RESPONSE TO TECHNICAL NOTICE OF
DEFICIENCY
PERMIT MODIFICATION REQUEST
Reconfiguration of Block O

City of Nacogdoches Landfill
Nacogdoches, Texas
TCEQ Permit No. MSW-720

Subject: City of Nacogdoches Landfill – Nacogdoches County
Municipal Solid Waste (MSW) – MSW Permit No. 720
Response to Technical Notice of Deficiency (NOD)
Permit Modification Request – Reconfiguration of Block O
Tracking No. 29534833; RN102217395/CN600134076

Figure 1. Section Location Plan for Section CC'

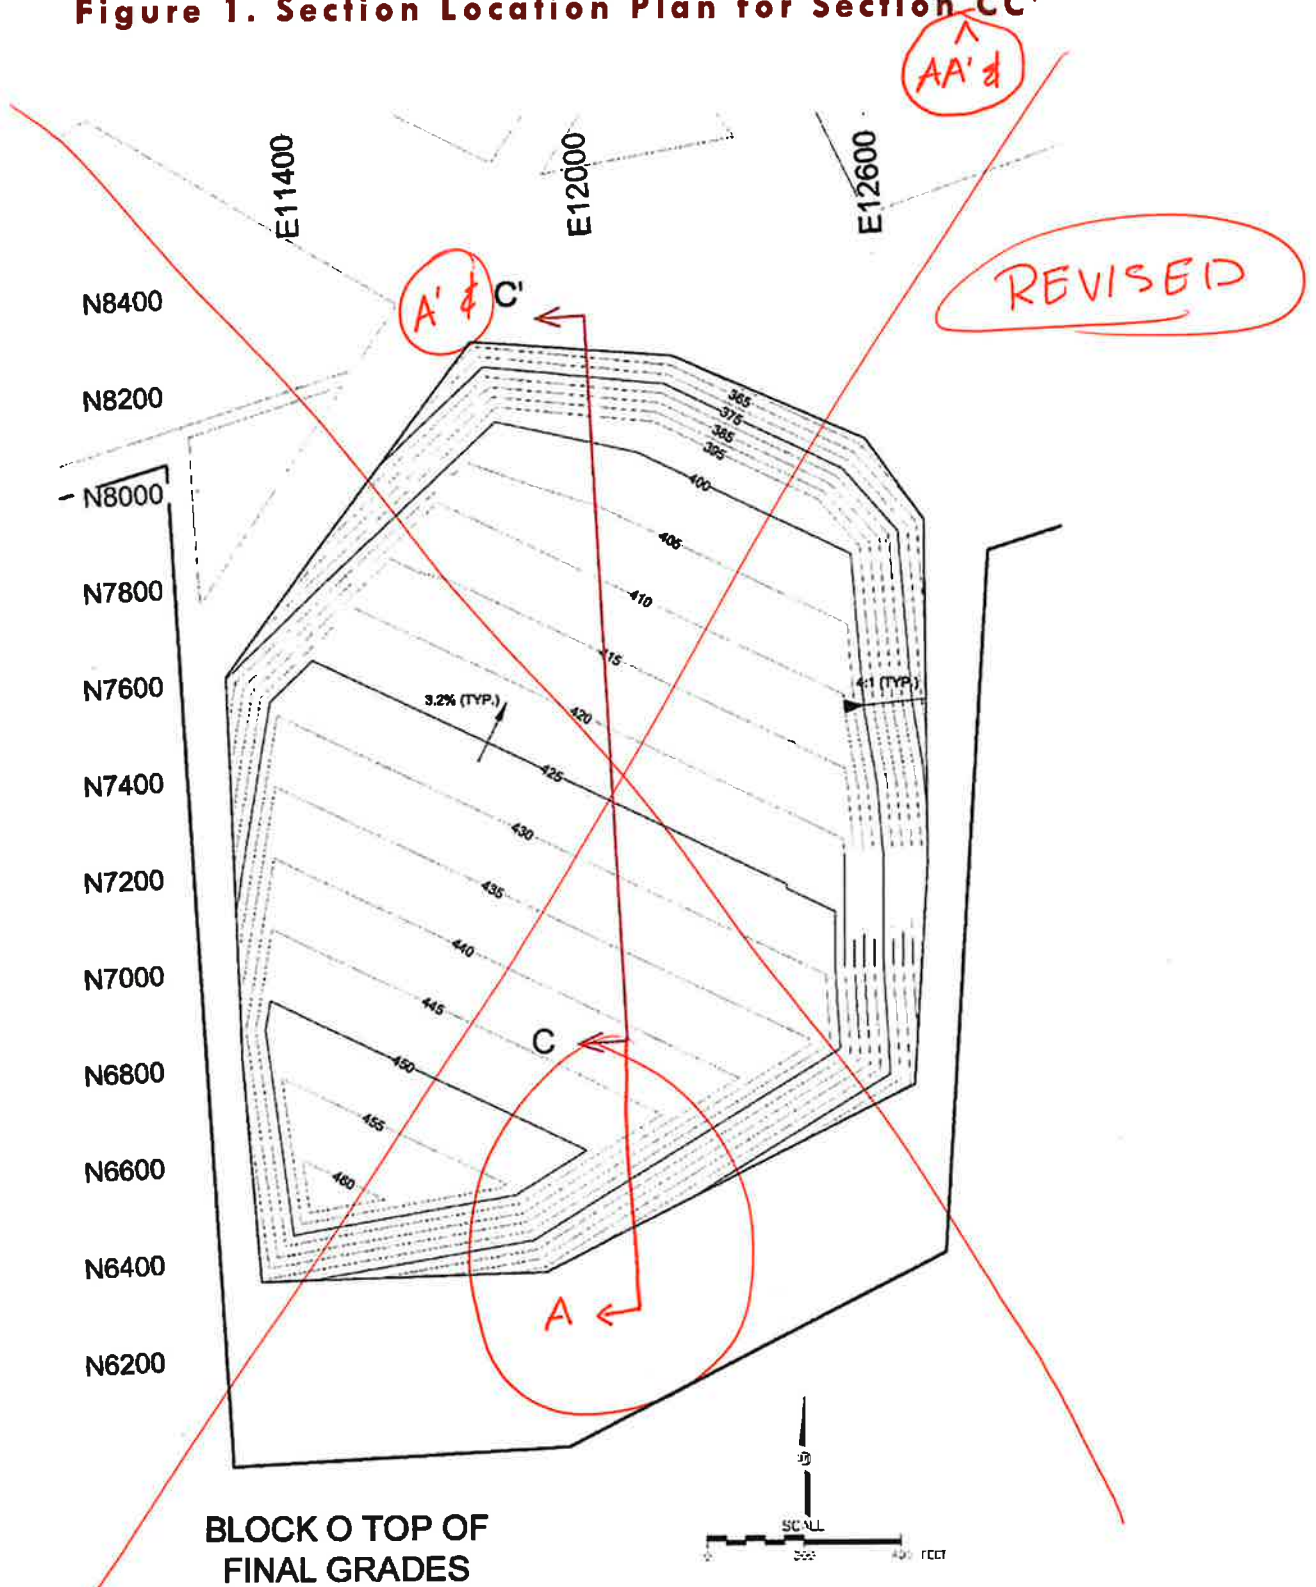
In PDF-I-2 page 16, plot the locations for both AA' and CC' on this plan map, and change the figure title to "for Section AA' & CC'" to be consistent with PDF-I-2 page 17.

PDF-I-2, page 16 or permit page C-1-8 is revised to show both AA' and CC' on the plan map and changed the Figure 1 title to "Section Location Plan for Section AA' and CC'".
